Re: Notice of Disapproval

**Completion Report for Regional Aquifer Well R-70, Revision 1, and the Response to the New Mexico Environment Department's Draft Comments on the Completion Report for Regional Aquifer Well R-70 Los Alamos National Laboratory
EPA ID#NM0890010515
HWB-LANL-19-080**

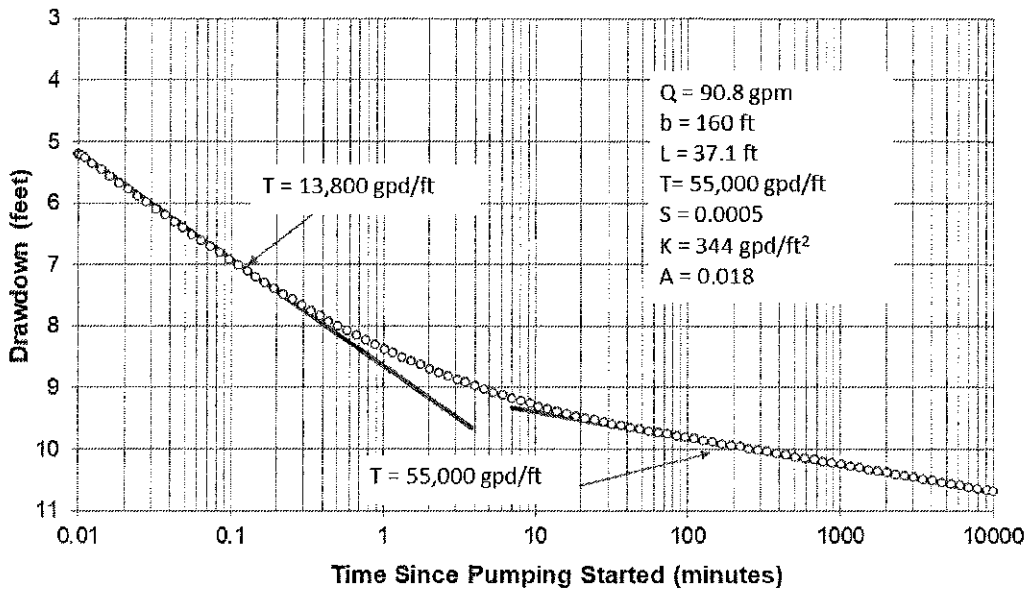
- a) Explain what is meant by the “vertical extent of the cone of depression” and “the effective height of the cone of depression”. Explain how these concepts differ from aquifer drawdown as described by many of the references provided below. Please provide supporting publications that explain the difference. If they are the same the conventional term “drawdown” should be used.

- b) Explain how the “vertical extent of the cone of depression” is limited to the well screen or filter pack length, knowing that the cone of depression occurs and expands laterally and vertically from along the water table regardless of the position of the well screen as shown by Driscoll (1986), Kruseman and de Ridder (1990), Lohman (1972), and described by Theis (1940) among many others. Provide supporting publications that explains how “the vertical extent of the cone of depression is limited to the well screen”. NMED sees this to be true only when the water table is intercepted by the well screen. However, in the case of R-70, which has two fully submerged screens, this statement is confusing.

Just as the zone of depressurization has a physical lateral extent (radius of influence) it has a height or thickness at any particular location (the distance between the upper and lower limits of the depressurized zone). This is what is referred to as the height of the cone of depression in the report.

14.b. The well screen length mentioned in the report refers to that of the pumped screen.

When pumping begins, the drawdown pressure wave rapidly expands horizontally through the sediments adjacent to the well screen. It also expands vertically, both upward from the screened interval and downward, though at a slow rate because of the low vertical hydraulic conductivity of the sediments compared to the horizontal conductivity. Drawdown thus occurs both above and below the screened interval, even though the images of cones of depression that NMED refers to always show a cone shape above the well screen. According to the USGS definition, the cone of depression is the "depression of heads," i.e., the drawdown—not a graphical picture representing the magnitude of the drawdown. In other words, saying that there is drawdown beneath the screen does not mean that water levels are pulled below the screen. Rather, it means that sediments beneath the screen see some drawdown below the previous static piezometric head there.

The transmissivity value computed from standard analysis techniques is the transmissivity of the thickness of sediments through which the cone of depression is expanding horizontally. Initially, this zone of expansion is limited to a thickness of sediments approximately equal to the screen length. Thus, the early slope on a drawdown graph should yield the transmissivity of only that thickness. As time passes, there is viable vertical growth of the cone of depression, meaning that the horizontal expansion of the cone takes place through a progressively thicker and thicker portion of the aquifer. This results in a steady flattening of the drawdown slope, as the data reflect the properties of a

Note that the initial slope on the graph produces a calculated transmissivity value of 13,800 gpd/ft, approximately equal to the known transmissivity of the screened interval (12,800 gpd/ft). This is because of the limited height of the cone of depression at early time. As the cone of depression (zone of depressurization) expands vertically throughout the test, a progressively greater effective transmissivity is reflected. Once the cone of depression is fully developed through the entire aquifer thickness, the data reflect the total aquifer transmissivity of 55,000 gpd/ft.
